AP1000 DOCUMENT NO. APP-GW-GLR-134	REVISION 1	PAGE 1 of 470	ASSIGNED TO W-Sterdis	OPEN ITEMS (Y/N)
----------------------------------------------	----------------------	-------------------------	---------------------------------	------------------

TITLE: AP1000 DCD Impacts to Support COLA Standardization

AP1000 Standard Combined License Technical Report

AP1000 DCD Impacts to Support COLA Standardization

Figure 9.3.6-1 (Sheet 1 of 2)

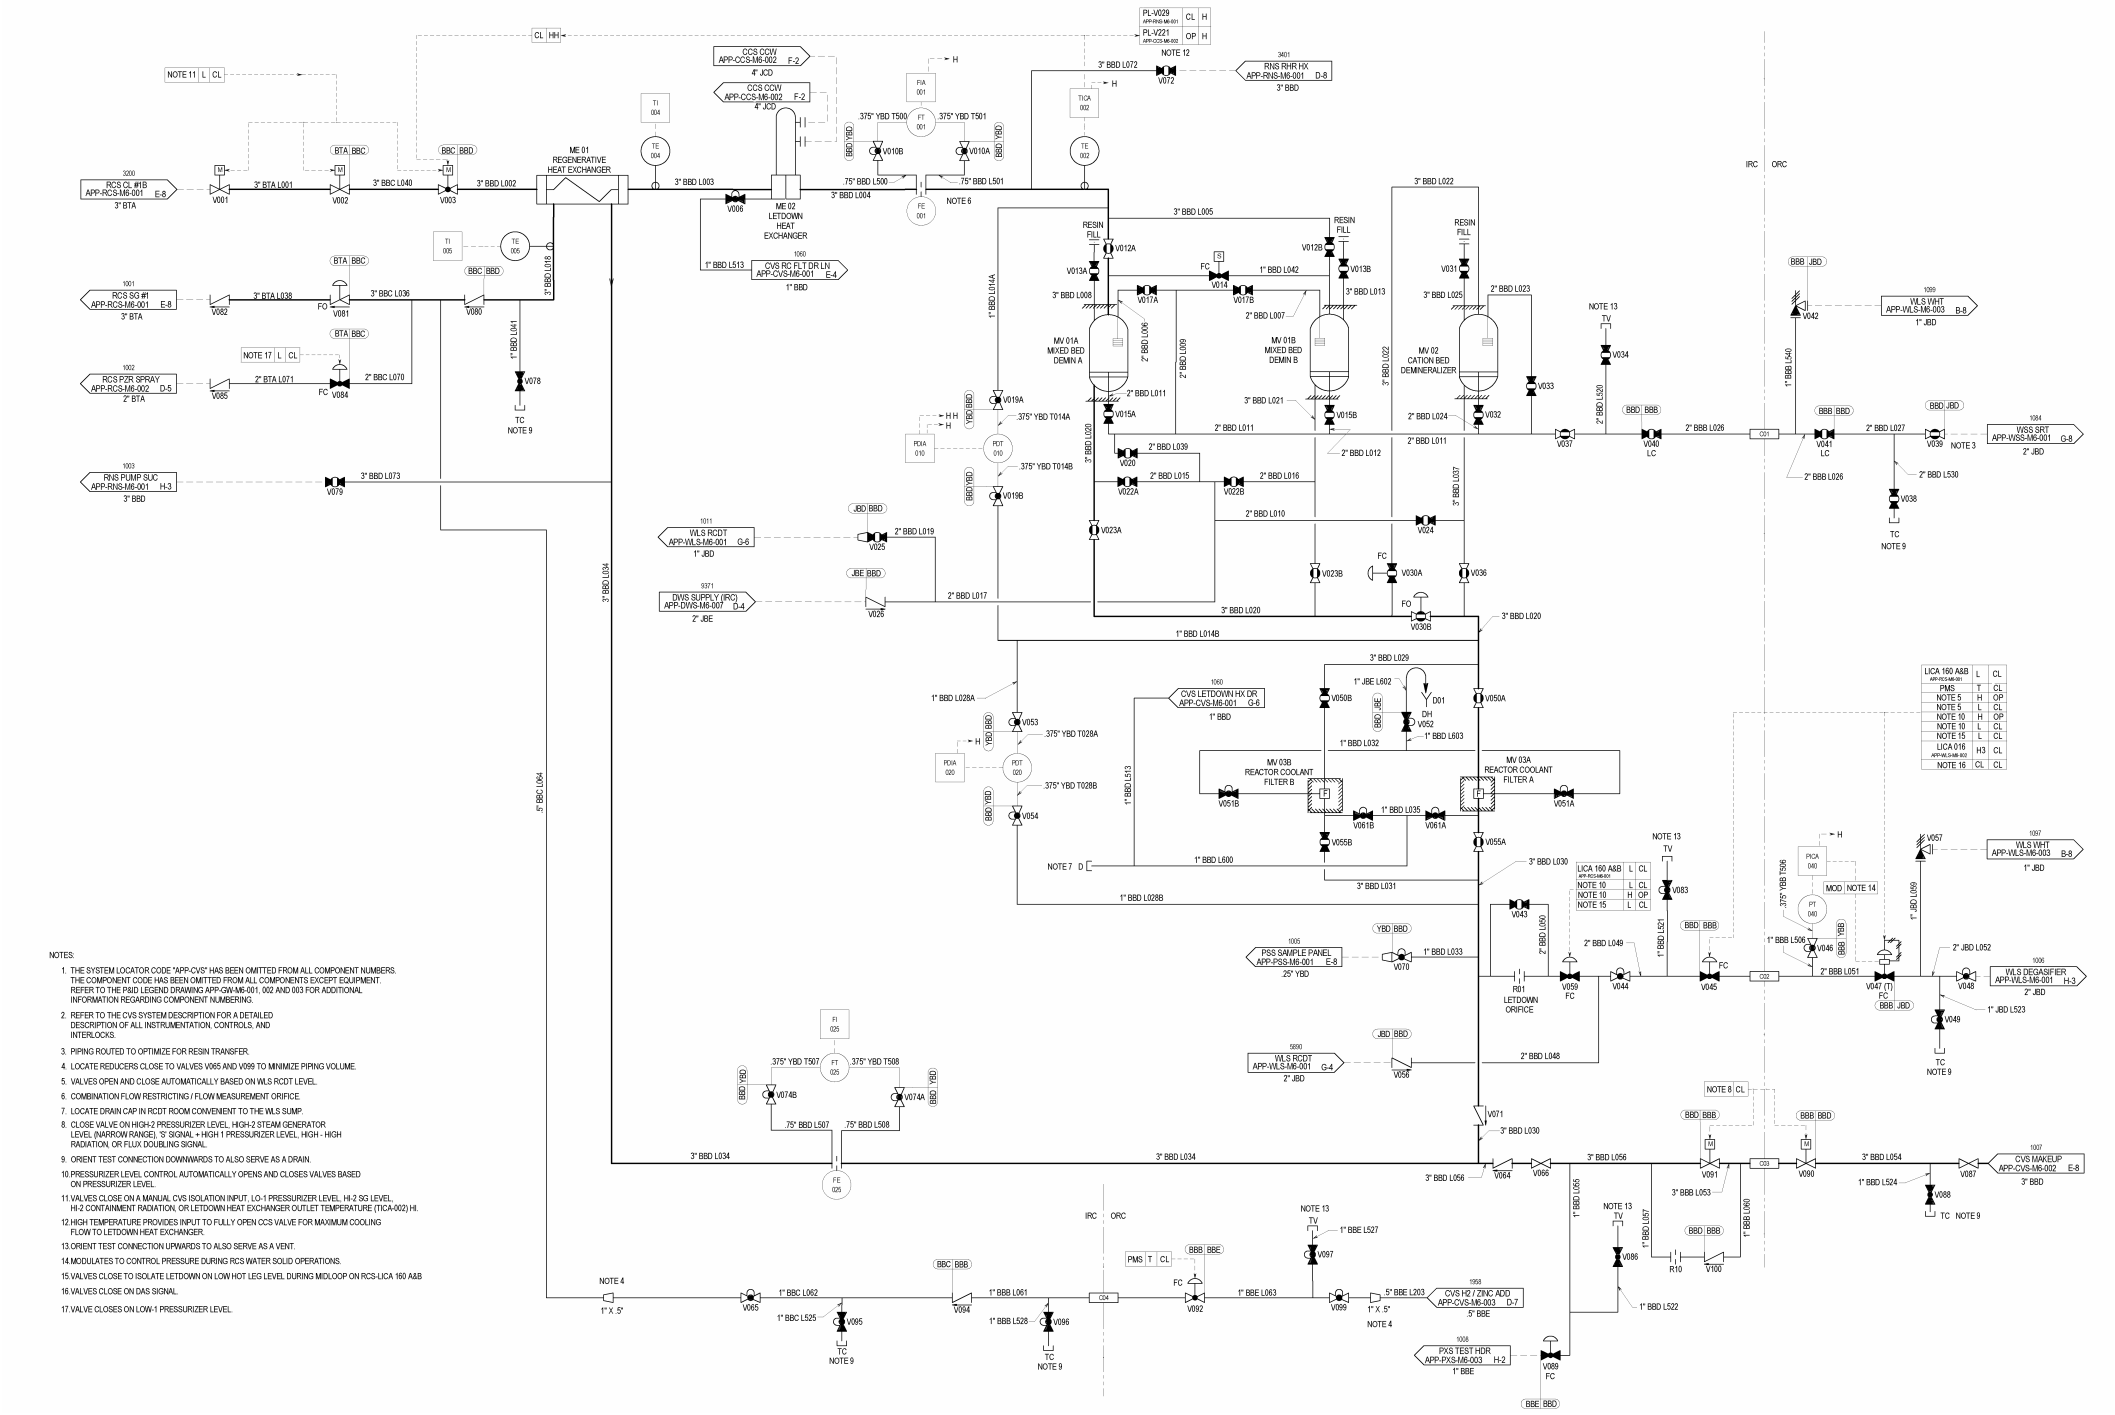
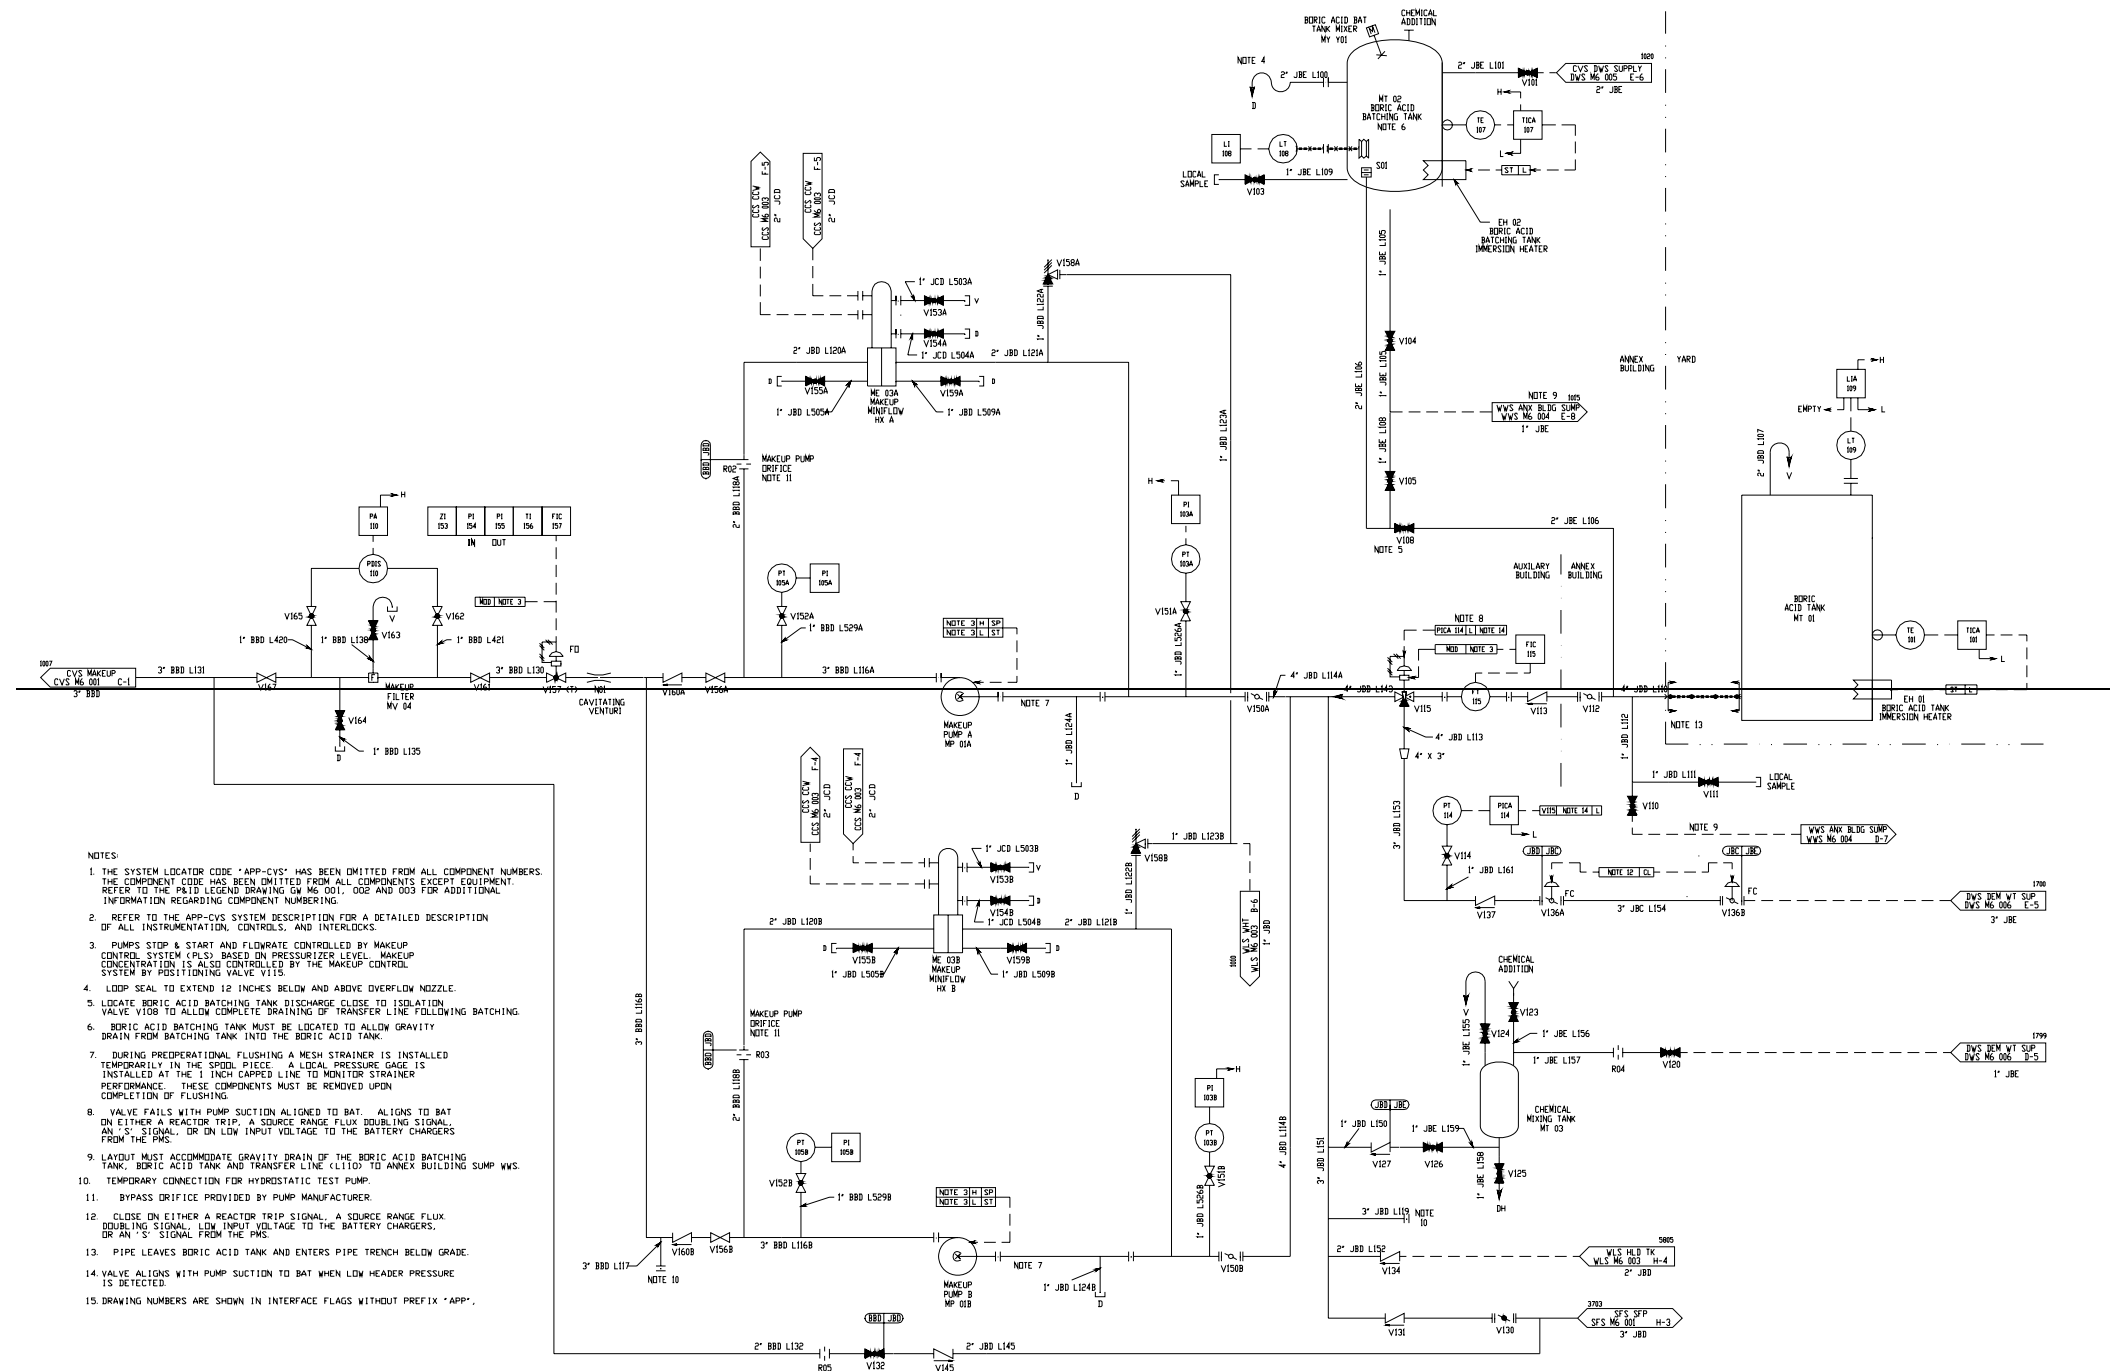
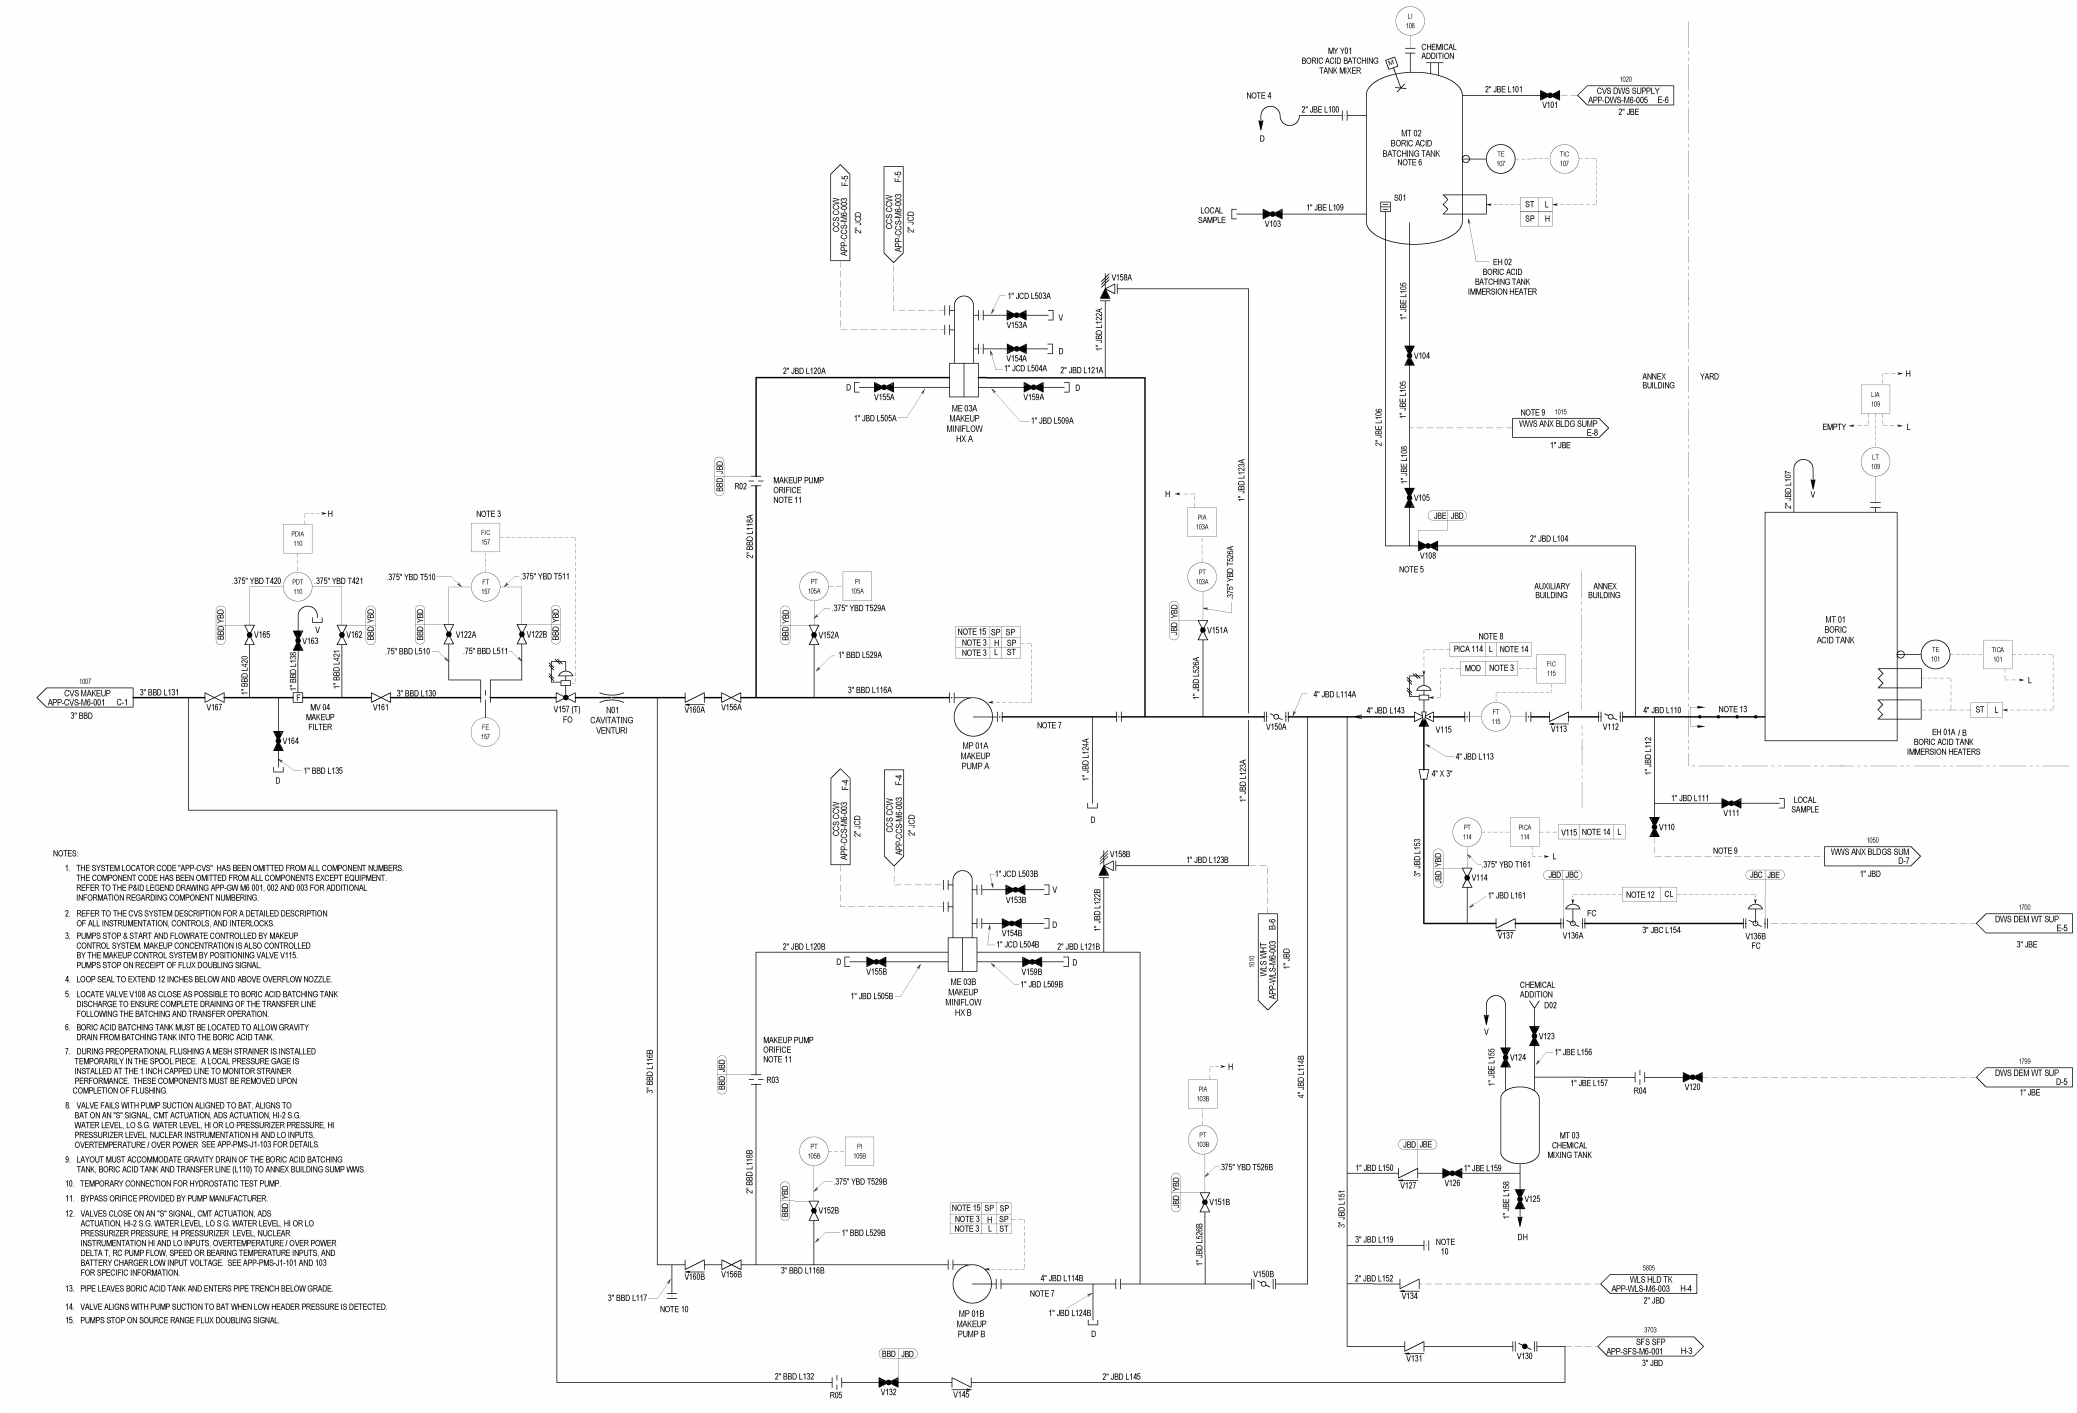
<i>DCD Section</i>	<i>Westinghouse Status</i>	<i>Tracking Number</i>	<i>DCD Category</i>	<i>Change Criteria</i>
9.3.6	Accepted for Revision 17	NRC157	Tier 2	NRC Prior Approval Not Required
<i>Description:</i> NRC157 contains changes to Section 9.3.6.3.7, 9.3.6.4.5.1, 9.3.6.6.1.2, 9.3.6.7 anf Figure 9.3.6-1(Sheets 1 & 2) of the DCD Revision 16 to be consistent with APP-GW-GLR-080,Rev 0.				
<i>Reference Information:</i> APP-GW-GLR-080 (TR80), Rev 0

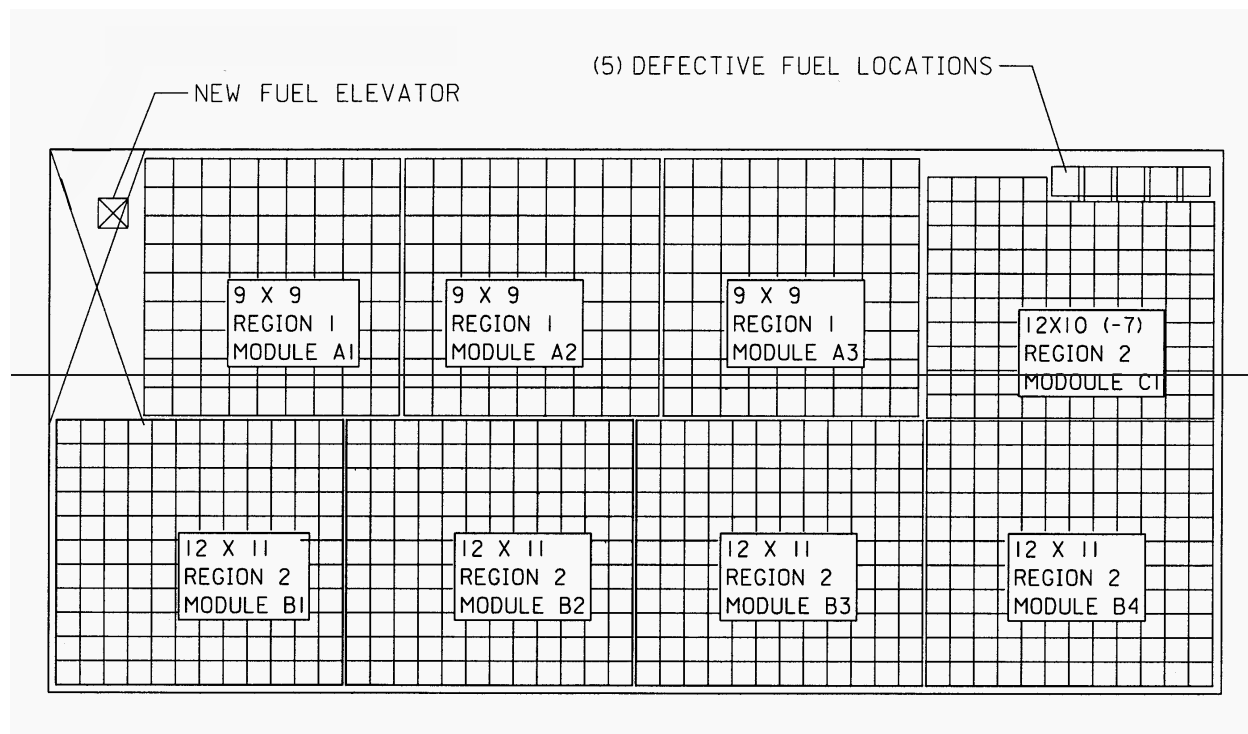
NRC100 contains corrections (typos) to TS 4.3.1 and Figure 4.3-1 of DCD Revision 16. The word "an" in the following statement will be changed to the word "any" in DCD Revision 17. "New or partially spent fuel assemblies with an discharge burnup may be allowed unrestricted storage in Region 1 and defective Fuel Cells of Figure 4.3-1". Figure 4.3-1, the word "module" was misspelled.
